**TENNESSEE VALLEY AUTHORITY (TVA) – MINOR PERMIT MODIFICATION – ASH
LANDFILL – KINGSTON FOSSIL PLANT**

RE: Proposed modification to approved construction and operation plans- Addition of foundation material and coal yard soil from the FGD Scrubber Project to the approved waste streams for disposal in TVA Kingston Coal Ash Landfill, IDL 73-0094

Request for Minor Permit Modification
IDL # 73-0094
Kingston Fossil Plant

TENNESSEE VALLEY AUTHORITY (TVA) - REQUEST APPROVAL FOR NEW
DREDGE CELL - KINGSTON FOSSIL PLANT (KIF)

TVA Kingston Temporary Dredge Cell - Plan view

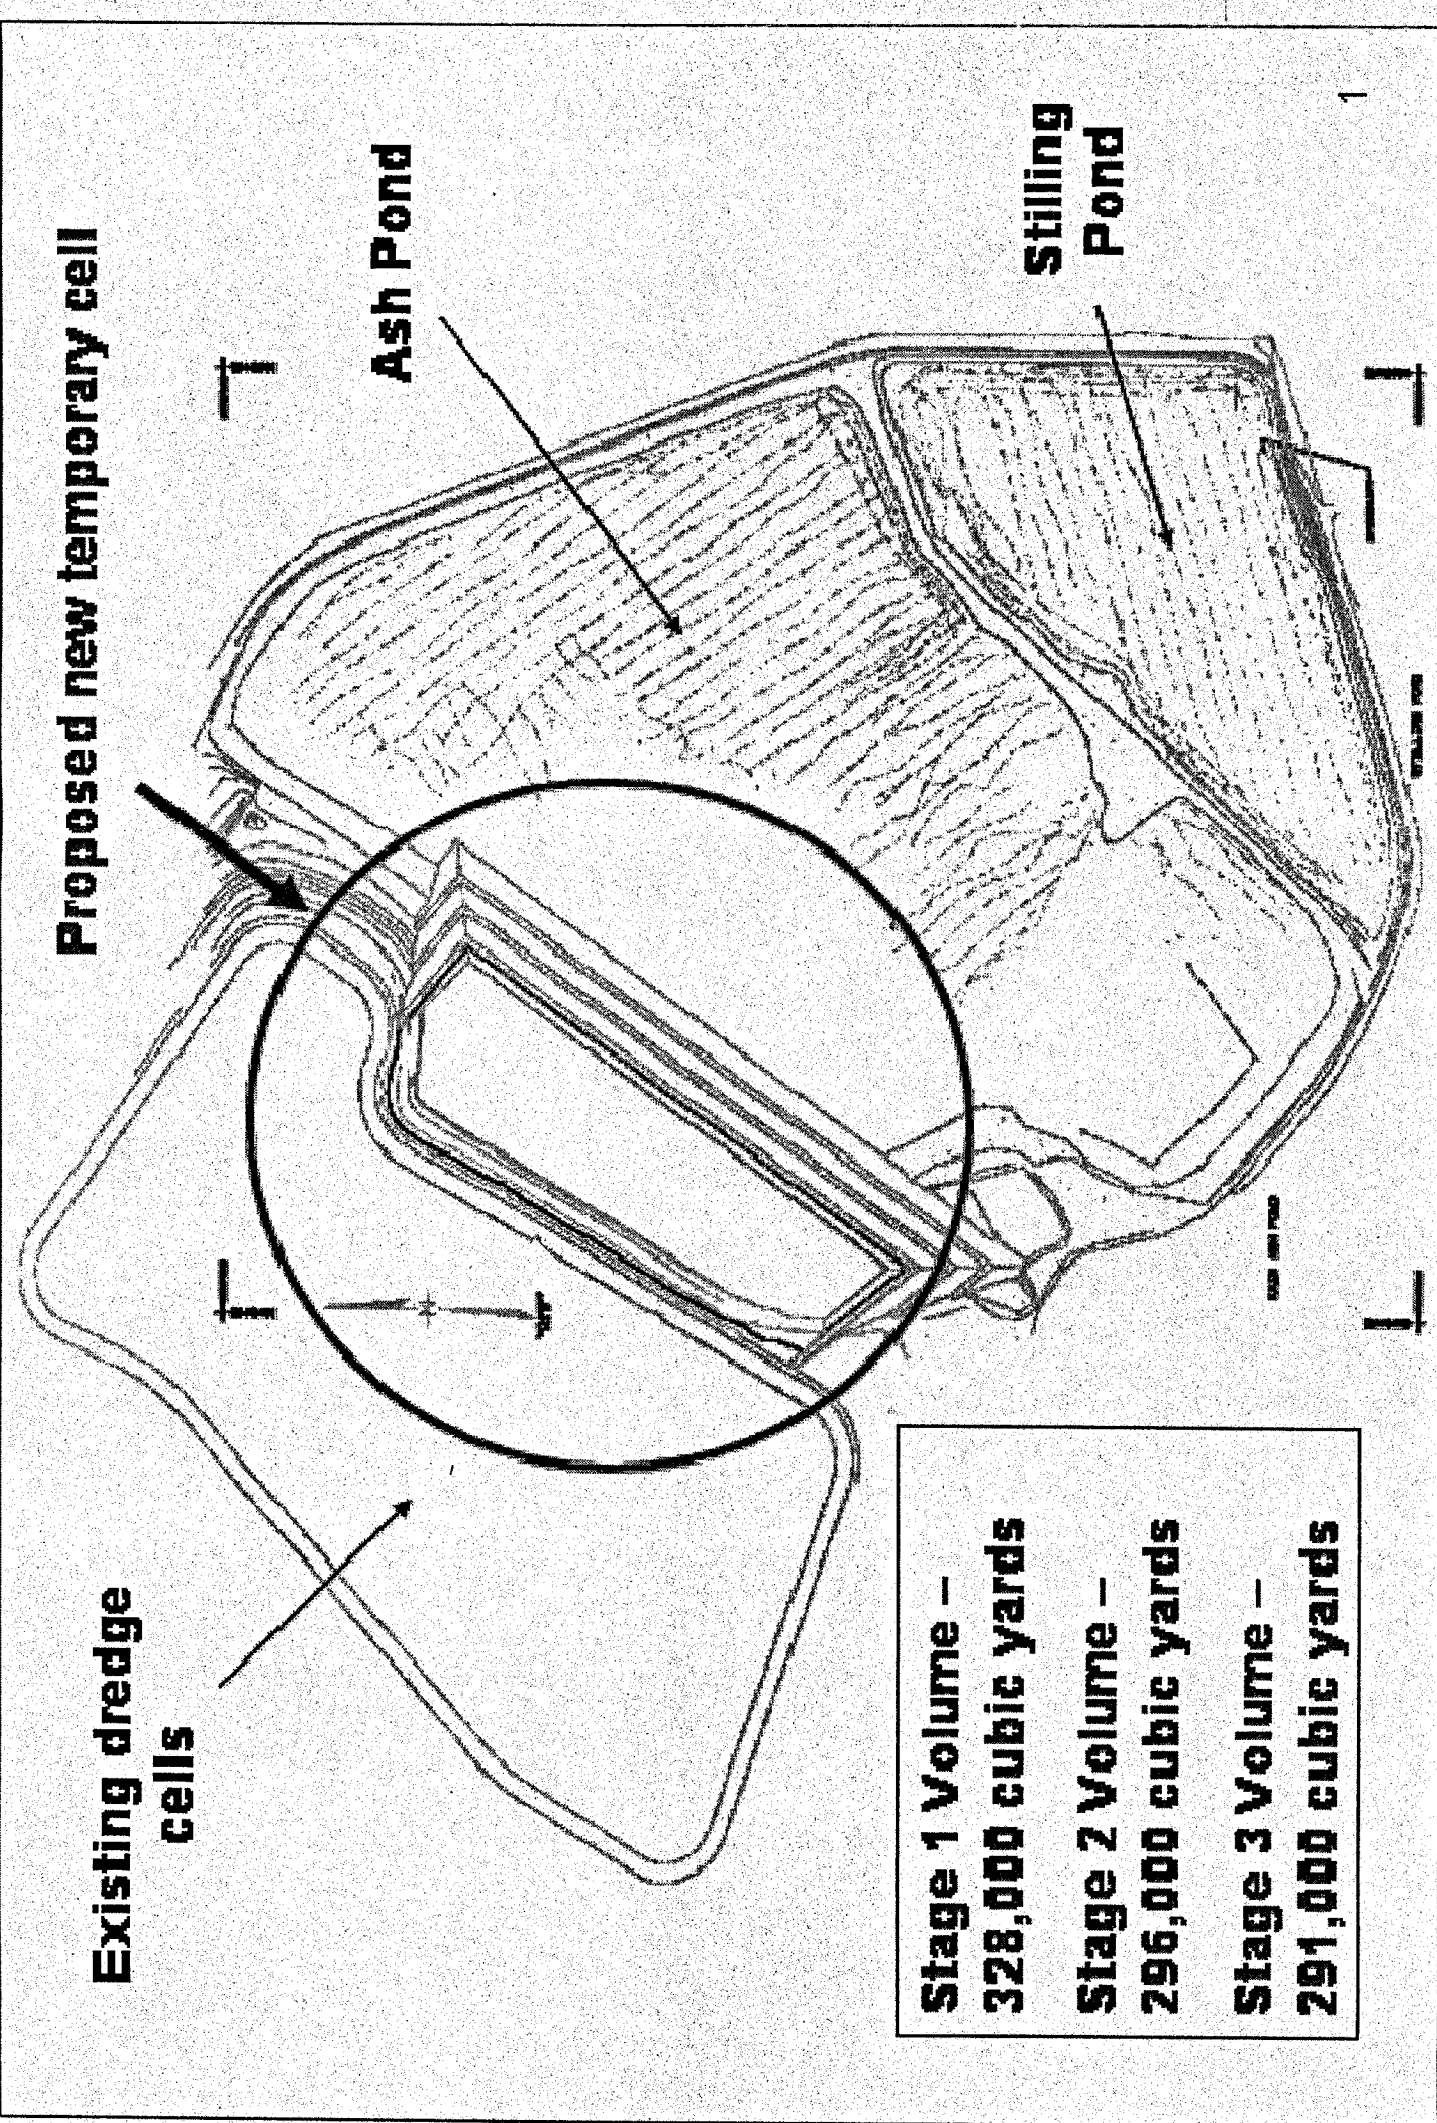
Thank you for meeting with members of my staff on December 30, 2003. As discussed in this meeting, TVA wishes to construct a new dredge cell within the confines of the existing ash pond at the KIF. TVA would like to begin construction of this cell by mid-January 2004 and begin using the cell by mid-February 2004. This dredge cell will be adjacent to the existing dredge cells permitted by IDL 73-0094 and will contain approximately 1,000,000 cubic yards of ash. Plans for this proposed dredge cell are enclosed. It should be noted that the area where this dredge cell will be constructed is within the boundary of a permit modification request for a lateral expansion which TVA will submit to the Division no later than June 1, 2004.

The Division has reviewed the request from TVA dated January 6, 2004 to construct a new dredge cell within the existing ash pond at Kingston Fossil Plant. We have also received a Part I Application from TVA for a Class II landfill which includes this same area. We hereby approve construction/operation to commence on the new dredge cell with the understanding that a complete Part II application for this area will be submitted by June 1, 2004.
